Office Action Summary	Application No. 10/786,480	Applicant(s) UEHARA ET AL.
	Examiner KEVIN NGUYEN	Art Unit 2629

2. Claims 1-20 are rejected under 35 U.S.C. 102(e) as being anticipated by Woodgate et al (US 7,058,252 hereafter Woodgate).

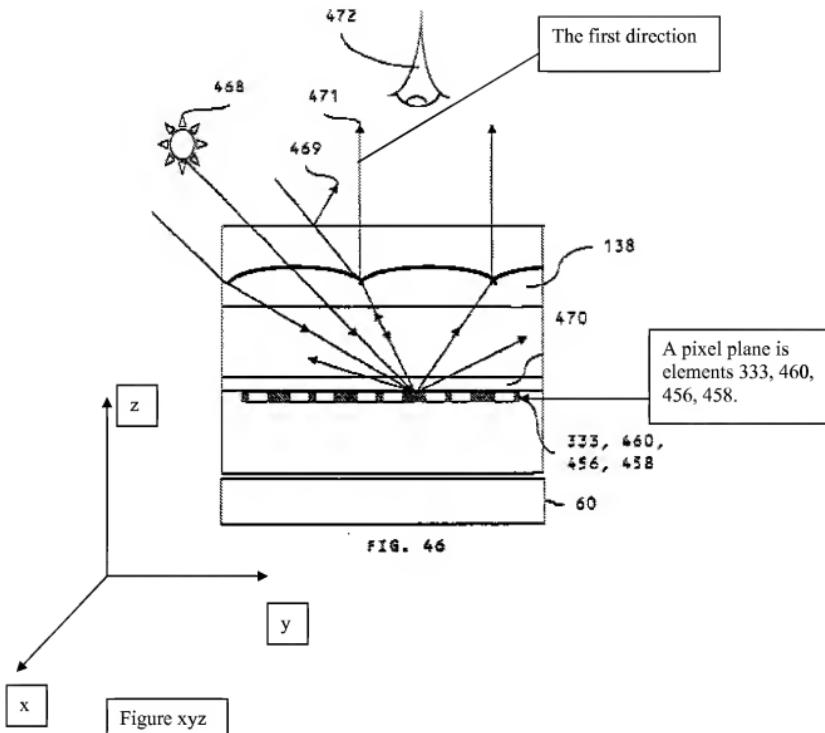
It is noted that the above-indicated limitations (a) (b) and (c) are not clear and confused. It is impossible to determine the equivalents of the element, as required by 35 U.S.C. 112, second paragraph. A first direction and the first direction are inconsistent. The first direction is lack of antecedent basis. Which one of a first direction or the first direction is perpendicular to a second direction?

In the ground of rejection of claim 1 above, the examiner should have clarified as following: In a top-sectional view of figure 44, and a cross-sectional view of figure 46, see the sketches on pages 11 and 13, Woodgate discloses a vertical gap 332 is parallel to column pixels 326, 328, 330 (as corresponding to a first direction as claimed). A horizontal gap 333 is parallel to the row pixels (alternate transmissive and reflective regions) 456, 460, 458 (as corresponding to the second direction as claimed). The horizontal gap 333 is parallel to two border lines of the transmissive and reflective regions 456, 460, 458. One skill in the art would recognize that the vertical gap 332, the horizontal gap 333, two border lines, the column pixels 326, 328, 330, and the row pixels 456, 460, 458 made up the pixel plane, which must be lying in the xy-plane. The vertical gap 332 is parallel to x-axis. The horizontal gap 333 is parallel to y-axis. X-axis is perpendicular to y-axis. Therefore, at least one column pixel 326 (a first direction) is perpendicular to at least one row pixel 456 (the second direction).

In the cross-sectional view of figure 46, Woodgate discloses the whole pixel plane as shown in figure 46 made up of one line, which contains elements 333, 460, 456, 458. It is noted that a line is made up of a plurality of pixels. These elements are supported in column 53, lines 13-15. Claim 1 requires "deflecting light emitted from said first and second pixels in (b) the first direction." The examiner should have clarified that the second paragraph of ground of rejection of claim 1 on page 3 as following: an optical unit (lens 138, fig. 46)deflecting light emitted from said first and second pixels in the first direction (e.g., the light beam 471, fig. 46). Claim 1 requires "said transmissive region and said reflective region are arranged in a second direction perpendicular to the first direction in each pixel." In the alternate embodiment, col. 40, lines 60-63, and col. 53, lines 45-50 of Woodgate further disclose the light beam 471 is maximum transmission that must orthogonal to the longitude direction of the lens 138 (as corresponding to the first direction as claimed). Therefore, the light beam 471 is perpendicular to the pixel plane (containing column pixels 332, 328, 330, and row pixels 456, 460, 458).

The applicant argues that claim 1 requires the emitted light be deflected in the first direction. These are not found to be persuasive. The reasons are as following: see the sketch above including three-dimensional coordinate system (x, y, and z) of figure 46. In the alternate embodiment, col. 40, lines 60-63, and col. 53, lines 45-50 of Woodgate further discloses a plurality of light beams are transmitted from the backlight 60, and are deflected by the lens 138.

At least one light beam 471 is maximum transmission, and must be orthogonal to the longitude direction of the lens 138. As the result, Woodgate discloses the light beam 471 corresponding to the first direction as recited in claim 1.

FIG.44

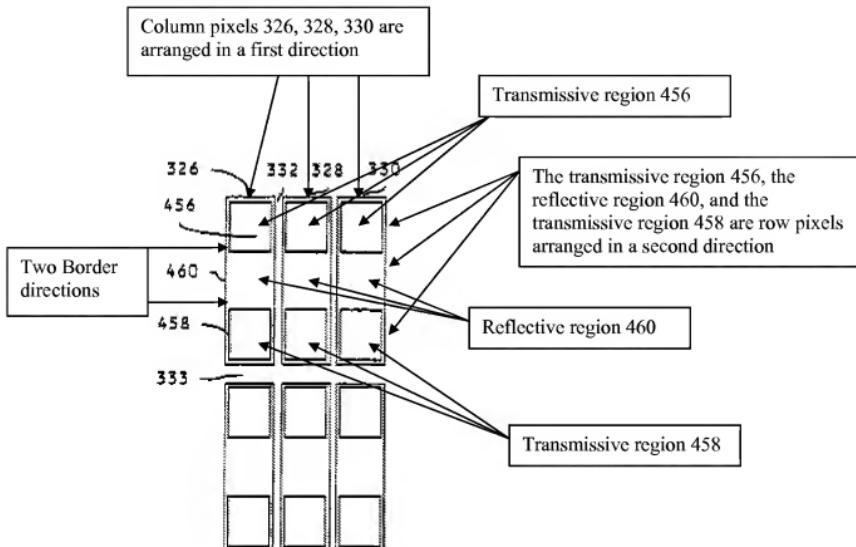
The applicant argues that "in Woodgate there is no disclosure of how these pixels are arranged..." last paragraph, on page 8. These are not found to be persuasive. In the top-sectional view of figure 44, see a sketch on page 13, Woodgate discloses the column pixels 326, 328, 330 (as corresponding to a first direction as claimed), and the row pixels (alternate transmissive and reflective regions) 456, 460, 458 (as corresponding to the second direction as claimed). As the result, Woodgate discloses the pixels are arranged as following: the column pixels 326, 328, 330, and the row pixels (alternate transmissive and reflective regions) 456, 460, 458.

The applicant argues that "the direction is different from the repeated arrangement direction of pixels of claim 16 of the present invention" last paragraph, on page 8. These are not found to be persuasive. Figure 44 of Woodgate discloses the direction is same and repeats arrangement direction of column pixel 326, column pixel 328, and column pixel 330, and row pixel 456, row pixel 460, and row pixel 458, see sketch of Figure 44. As the result, Woodgate discloses ""the direction is NOT different from the repeated arrangement direction of pixels" as recited in claim 16.

With respect to the applicant's argument of claim 16 on page 9, the examiner should have clarified as following: In the top-sectional view of figure 44, Woodgate discloses the transmissive region is made up of three sub-pixels 456, and the reflective region is made up of three sub-pixels 460. Claim 16 requires, each pixel includes a transmissive and a reflective region. It is noted that a pixel is made up of three sub-pixels RGB. Therefore, each transmissive region 456 is made up of three sub-pixels RGB 456, an each reflective region 460 is made up of three sub-pixels RGB 460.

Applicant argues on page 9, Woodgate does not teach or suggest that each reflective region 460 and each transmissive region 458 is divided into a red sub-region, green sub-region, and blue sub-region. These are not found to be persuasive. Woodgate further discloses a column of red pixels 326, a column of blue pixels 328, and a column of green pixels 330. These elements are supported in column 52, lines 41-44. Furthermore, Woodgate further discloses a row pixel of transmissive region 456, a row of reflective region 460, and a row of transmissive region 458. Therefore, three columns of pixels 326, 328, 330 are intersected by three rows of pixels 456, 460, 458 that would be divided into a red sub-region, green sub-region and blue sub-region as required in claim 16. As the result, Woodgate teaches "each of said transmissive region and said reflective region is divided into a red sub-region, green sub-region and blue sub-region."
